Revised Guidance on Various EC Notifications

TD-2305M-JA02, “Electric Distribution Overhead Inspection Job Aid”

WOODPECKER DAMAGE 1-3 INCHES

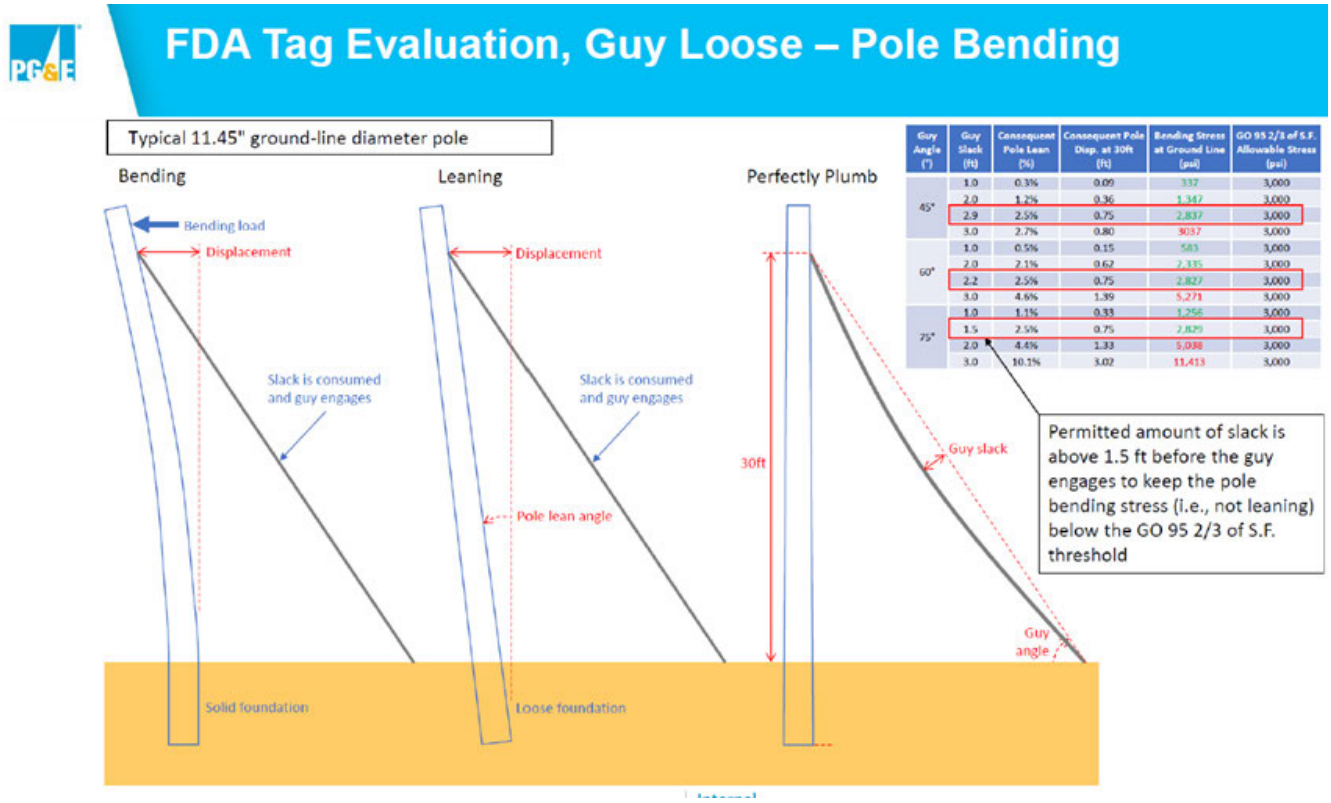
The photo example on page 58, titled: “Woodpecker Damage 1-3 inches,” in the Overhead Job Aid is INCORRECT. Please *disregard this photo* and refer to the Woodpecker process flow (page 52) within the OHJA for appropriate guidance.

INCORRECT – DO NOT USE

REFER TO PROCESS FLOW
